## Response to Submissions Report

State Significant Development - SSD-11920082

Hastings Secondary College Port Macquarie Campus Upgrade

16 Owen Street, Port Macquarie

Figure 1 Approved and proposed heights (source fjmt and FKG)

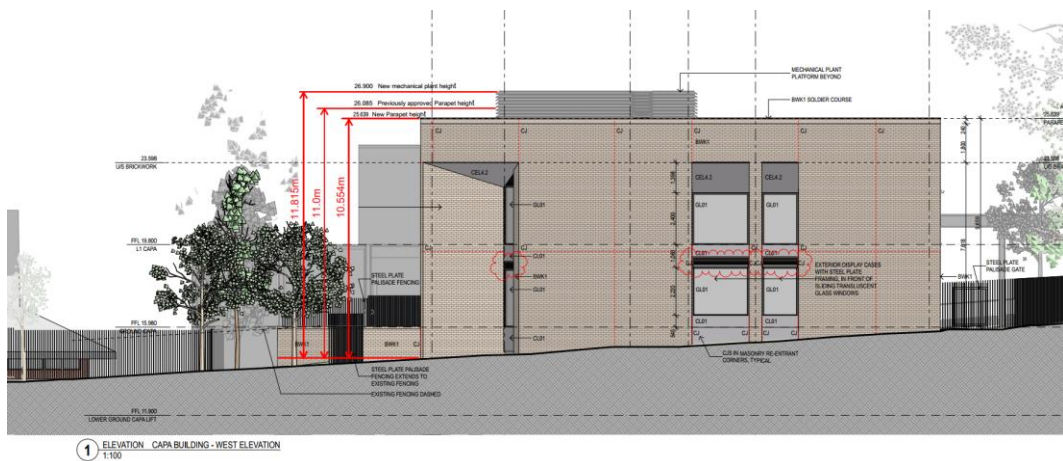
Issue	Response	Reference
(1) Further view loss from the addition of the mechanical plant to the east of the CAPA building on top of the walkway roof.	Refer Section 4.1 of this report	Visual Impact Assessment – Addendum Letter, Prepared by Ethos Urban, Version 4, dated 16 November 2022

Figure 1 demonstrates the approved and proposed heights of the CAPA building and mechanical plant to the rear of the CAPA building on top of the covered walkway.
